1201 F / 1201 FP

The new model 1201 F offers important improvements in comparison to the previous model (1200 F).

Fig. 1

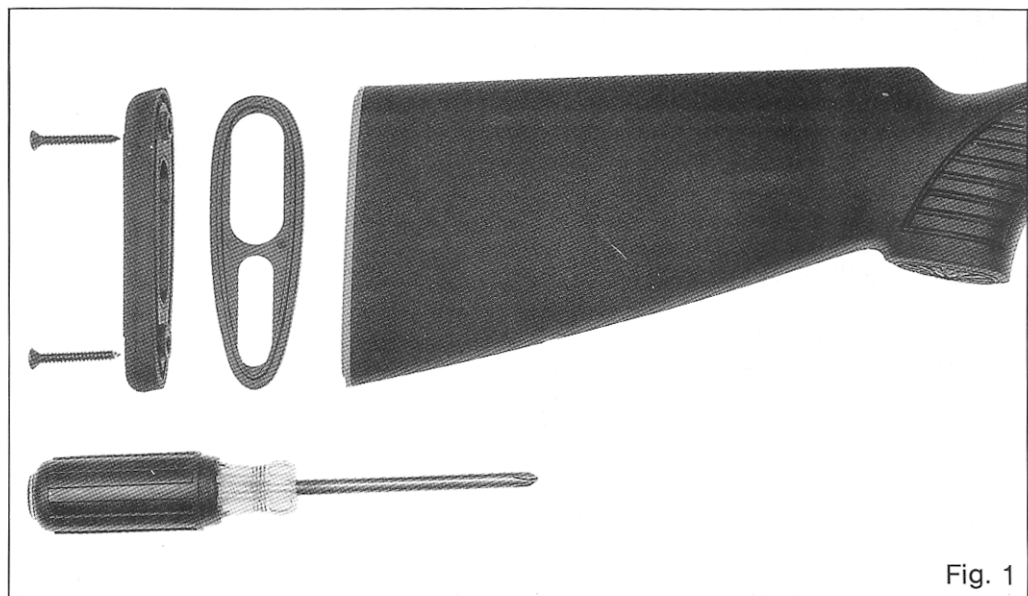
Both models 1201 F and 1201 FP are normally factory set with a heel drop of 60 mm.

In order to modify the drop it is necessary to use the appropriate modification set consisting of a metal plate and a plastic spacer.

Available sets as follows:

- 60 mm. set (factory set)
- 55 mm. set on request
- 50 mm. set on request

It is advised to have the operation carried out by a competent gunsmith (use a 13 mm. hexagonal tube spanner, after removing rubber recoil pad with a medium sized cross-point screwdriver).
